Project Number: 3613	Rockland Plaza Winners - Addendum 02 (Q & A)	January 14, 2025
----------------------	--	------------------

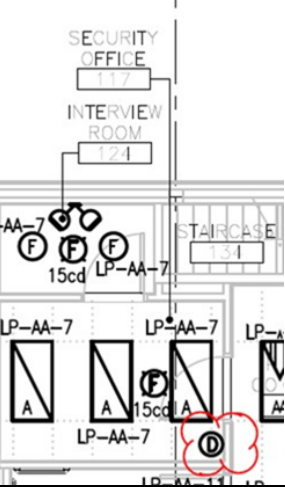
16	GWAL (ELECTR)	FACP. is it from top or bottom & how many?	Please see picture above. Given that the panel is recessed, we can not advise on incoming conduit. Once the wall is opened, and we can see where the feed is coming from and the electrical contractor will be in charge of assessing and providing all the necessary conduit / wire, relocating and feeding it from above or below, depending on what this current setup is.	16-Dec-24	ADD 1
17	GWAL (ELECTR)	Note # 61 is attached to Panel LP-B3 but the note# 61 detail missing, please provide.	Note 61 is in fact note 49. We will revise.	16-Dec-24	ADD 1
18	GWAL (MECH)	Please provide correct RTU numbers on new SLD & on Roof units.	Single line diagram will be revised to show the correct RTU names.	16-Dec-24	ADD 1
19	DCA	Are non-OIRCA roofers allowed to do this job?	Yes, Roofers can be non-OIRCA.	16-Dec-24	ADD 1
